Access Compliance Report

Public Rights-of-Way

(Curb Ramps)

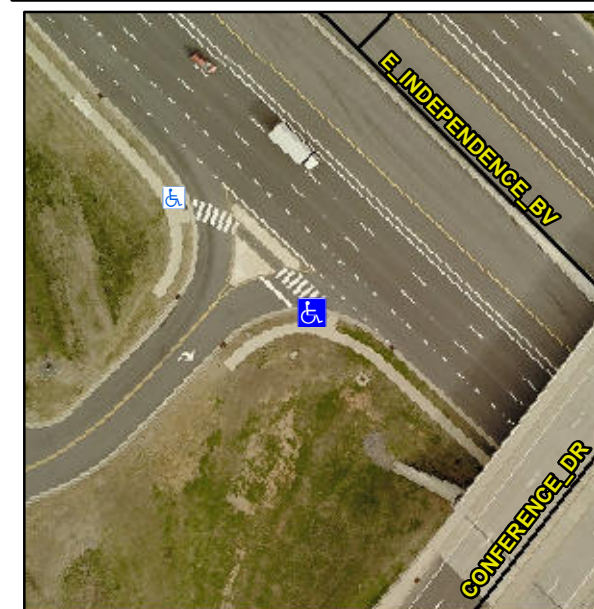
Intersection ID: 17435	Main Street: E_INDEPENDENCE_BV	Cross Street: BUICK_DR	Location: SW
ADA ID: 24B11EE25830	Ramp Type: Perp	Initial Pass/Fail: Fail	Overall Compliance: No
Severity Score: 12.5			
Codes/Mitigation Info/Possible Solution		Field Measurements/Component Compliance

Not Found, R304.2.2

Compliance	Description	Data	Compliance	Description	Data
N/A	Ramp Length (in)	72.0	No	Ramp Slope (%)	10.2
Yes	Ramp Width (in)	59.0	Yes	Ramp XSlope (%)	1.3
N/A	Flare Type LT	N/A	N/A	Flare Type RT	N/A
N/A	Flare Slope LT (%)	N/A	N/A	Flare Slope RT (%)	N/A
N/A	Flare Traversable LT?	N/A	N/A	Flare Traversable RT?	N/A
N/A	Landing Length (in)	N/A	N/A	DWS Provided?	N/A
N/A	Landing Width (in)	N/A	N/A	DWS Contrast?	N/A
N/A	Landing Slope (%)	N/A	N/A	DWS Length (in)	N/A
N/A	Landing X Slope (%)	N/A	N/A	DWS Full Width?	N/A
N/A	Landing Curb? (Y/N)	N/A	N/A	DWS Offset (in)	N/A
N/A	Shared Landing?	N/A			
N/A	Gutter Ponding?	N/A	N/A	Gutter Slope (%)	N/A
N/A	Gutter Lip Ht (in)	N/A	N/A	Gutter X Slope (%)	N/A
N/A	Painted X Walk1?	Yes	N/A	Painted X Walk2?	N/A
	X Walk 1 Direction	To NW		X Walk 2 Direction	N/A
N/A	X Walk 1 Width (in)	120.0	N/A	X Walk 2 Width (in)	N/A
	X Walk 1 Slope (%)	1.4		X Walk 2 Slope (%)	N/A
	X Walk 1 X Slope (%)	1.1		X Walk 2 X Slope (%)	N/A

Remove & Replace Entire Ramp.
